## DHC-8 (DASH 8)

### SERVICE BULLETIN 84-26-20

#### **Fire Protection – Fire Detection System – Nacelle Fire Detection System – Main Landing Gear (MLG) Primary Zone – Advanced Pneumatic Detectors (APD) – Special Inspection and Rectification – ModSum 4-114036**

This page transmits Revision 'A' of Service Bulletin 84-26-20, pages 1 thru 14, dated 09 Mar 2021.

**MLG Primary Zone APD Sensing Line (Element) – Location  
Figure 2**

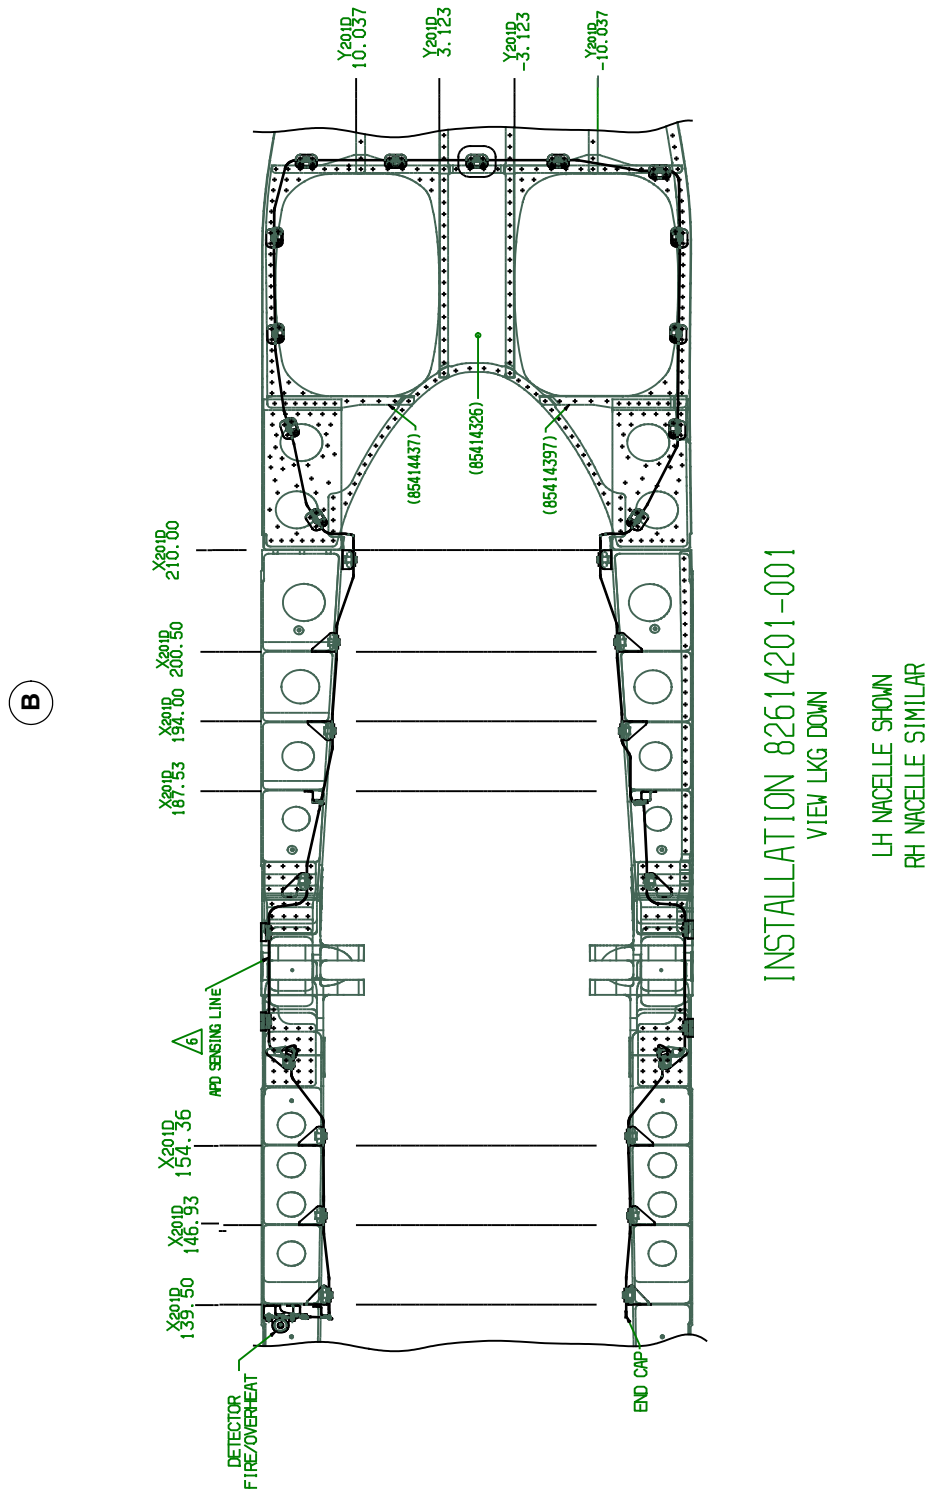
INSPECT CLEARANCE BETWEEN MLG PRIMARY ZONE APD SENSING LINE AND SURROUNDING STRUCTURE AS WELL AS CLEARANCE BETWEEN OTHER SYSTEM COMPONENTS INSTALLED IN VICINITY OF THE MLG PRIMARY ZONE APD SENSING LINE IN THE MAIN LANDING GEAR BAY AREA, IN THE LHS AND RHS NACELLES.

**Hydraulic Tube – Location (RH Nacelle)**  
**Figure 3**

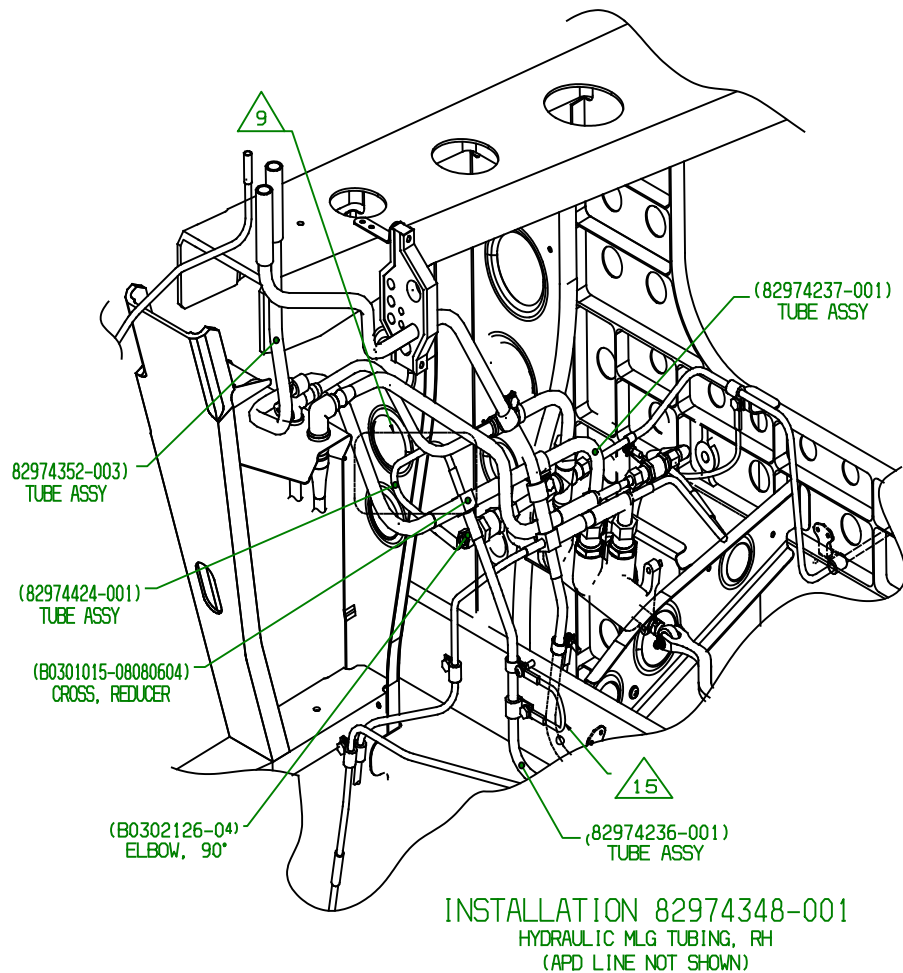
NOTE: Approximate inspection area is located at RHS Nacelle X201D 187.53 (refer to Figure 3). Approximate inspection area is located at LHS Nacelle X201D 187.53 (refer to Figure 4).

- △ 6 INSPECT CLEARANCE BETWEEN MLG PRIMARY ZONE APD SENSING LINE AND SURROUNDING STRUCTURE AS WELL AS CLEARANCE BETWEEN OTHER SYSTEM COMPONENTS INSTALLED IN VICINITY OF THE MLG PRIMARY ZONE APD SENSING LINE IN THE MAIN LANDING GEAR BAY AREA, IN THE LHS AND RHS NACELLES.
- △ 9 INSPECT TUBE ASSEMBLY 82974424-001 LOCATED IN THE RHS NACELLE FOR CHAFING DAMAGE. APPROXIMATE INSPECTION AREA IS LOCATED AT RHS NACELLE FRAME X201D 187.53, AS SHOWN IN THE ISO VIEW.
- △ 15 IF TUBE ASSY 82974236-001 IS RE-INSTALLED, INSTALL BONDING STRAP (B0312009BB6) AND BONDING CLAMP (AN735C6) AS SHOWN. INSTALL BONDING STRAP PER AMM TASK 51-80-00-400-801.

NOTE: If Tube Assembly 82974236-001 is re-installed , install Bonding Strap B0312009BB6 and Bonding Clamp AN735C6 as shown in the Figure 3 and Figure 4 (refer AMM TASK 51-80-00-400-801).

**Hydraulic Tube – Location (LH Nacelle)**  
**Figure 4**

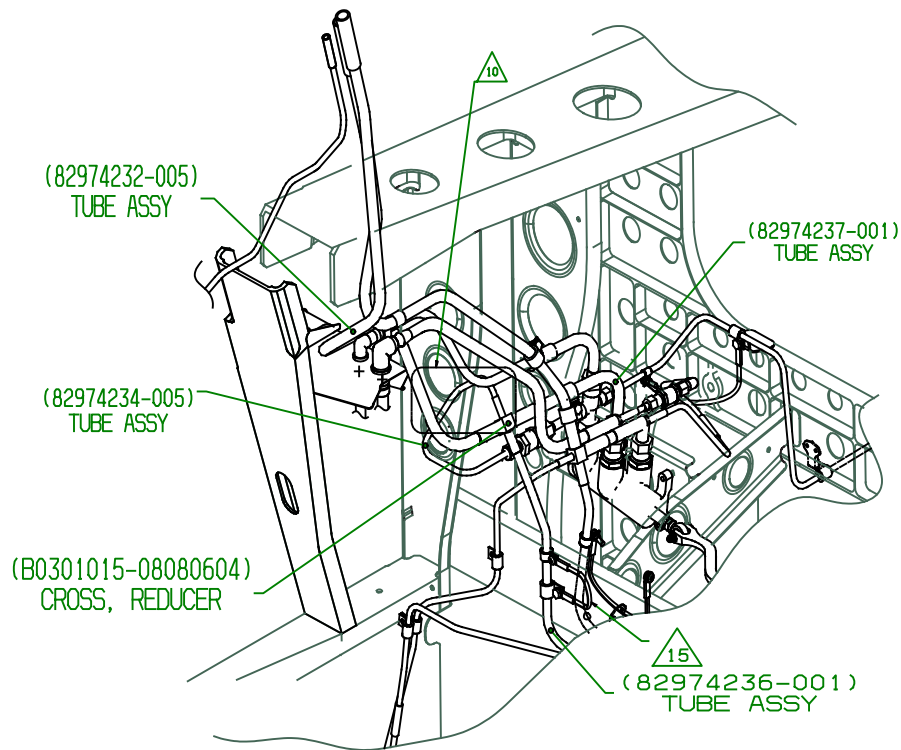
- **Figure 3** is revised and **Figure 4** is added for tube installation at LH nacelle location and additional notes.

INSPECT CLEARANCE BETWEEN MLG PRIMARY ZONE APD SENSING LINE AND SURROUNDING STRUCTURE AS WELL AS CLEARANCE BETWEEN OTHER SYSTEM COMPONENTS INSTALLED IN VICINITY OF THE MLG PRIMARY ZONE APD SENSING LINE IN THE MAIN LANDING GEAR BAY AREA, IN THE LHS AND RHS NACELLES.
- △  
10

INSPECT TUBE ASSEMBLY 82974234-( ) LOCATED IN THE LHS NACELLE FOR CHAFING DAMAGE. APPROXIMATE INSPECTION AREA IS LOCATED AT LHS NACELLE FRAME X201D 187.53, AS SHOWN IN THE ISO VIEW.
- △  
15

IF TUBE ASSY 82974236-001 IS RE-INSTALLED, INSTALL BONDING STRAP (B0312009BB6) AND BONDING CLAMP (AN735C6) AS SHOWN. INSTALL BONDING STRAP PER AMM TASK 51-80-00-400-801.
